Product Change Notification

■Product list PCN2022-13_EM30MSD(※※) Material change

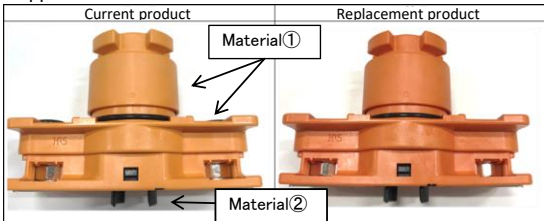
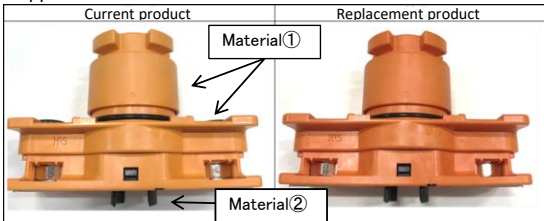
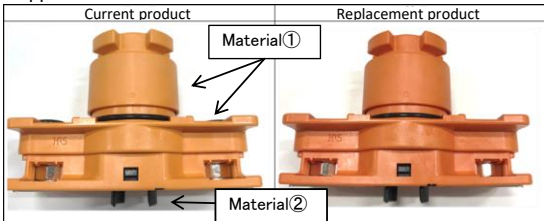
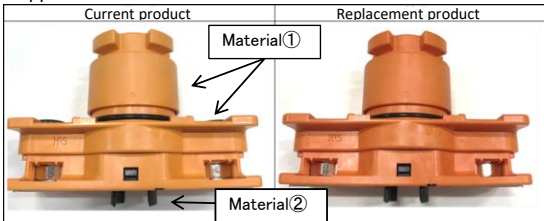
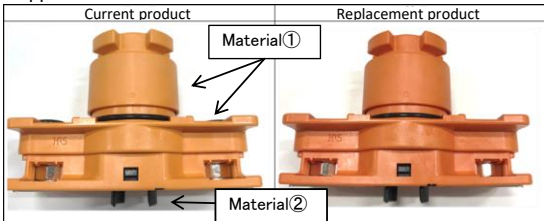
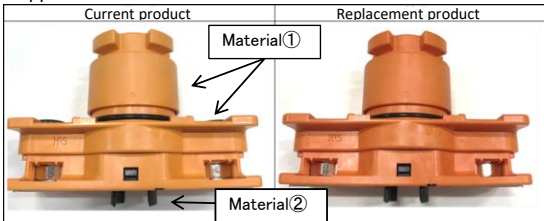
| 1 | Products affected | Please refer to the attachment 1 for detailed product names. | | | | | | | | | | | | | | | | | | | | | | | | | | | | | | | | | | |
|--|--|--|--|-----------------|---------------------|---------------------|-----|--|--------------|---|--|-------------|--------------|--------------|----------|---------|--|--|-----------------|---------------------|---------------------|-----|--|--------------|-------------------------------|------------------------|-------------|------|------|----------|---------|--|-----------------|---------------------|--|--|
| 4 | Changes | <p>Considering the discontinuation of production by the resin manufacturer and the stable supply in the future, the material of the insulator will be changed. These changes will not affect the performances of the product.</p> <p>【Material① (Orange resin)】</p> <table border="1"> <thead> <tr> <th></th> <th>Current product</th> <th>Replacement product</th> </tr> </thead> <tbody> <tr> <td>Material properties</td> <td colspan="2">PBT</td> </tr> <tr> <td>Manufacturer</td> <td colspan="2">Mitsubishi Engineering-Plastics Corporation</td> </tr> <tr> <td>Part number</td> <td>5010GN1-30AM</td> <td>5010GN6-30TS</td> </tr> <tr> <td>UL Grade</td> <td colspan="2">UL94V-0</td> </tr> </tbody> </table> <p>【Material② (Black resin)】</p> <table border="1"> <thead> <tr> <th></th> <th>Current product</th> <th>Replacement product</th> </tr> </thead> <tbody> <tr> <td>Material properties</td> <td colspan="2">PBT</td> </tr> <tr> <td>Manufacturer</td> <td>Chang Chun Plastics Co., Ltd.</td> <td>POLYPLASTICS CO., LTD.</td> </tr> <tr> <td>Part number</td> <td>4130</td> <td>3316</td> </tr> <tr> <td>UL Grade</td> <td colspan="2">UL94V-0</td> </tr> </tbody> </table> <p>◆Appearance</p> <table border="1"> <thead> <tr> <th>Current product</th> <th>Replacement product</th> </tr> </thead> <tbody> <tr> <td></td> <td></td> </tr> </tbody> </table> <p>Although there is a change in color due to a change in materials, the product shape itself remains unchanged.</p> <p>The product code and product name will be changed for the replacement product. UL reapplication has been completed with the changed materials and certification has been obtained.</p> | | Current product | Replacement product | Material properties | PBT | | Manufacturer | Mitsubishi Engineering-Plastics Corporation | | Part number | 5010GN1-30AM | 5010GN6-30TS | UL Grade | UL94V-0 | | | Current product | Replacement product | Material properties | PBT | | Manufacturer | Chang Chun Plastics Co., Ltd. | POLYPLASTICS CO., LTD. | Part number | 4130 | 3316 | UL Grade | UL94V-0 | | Current product | Replacement product |  |  |
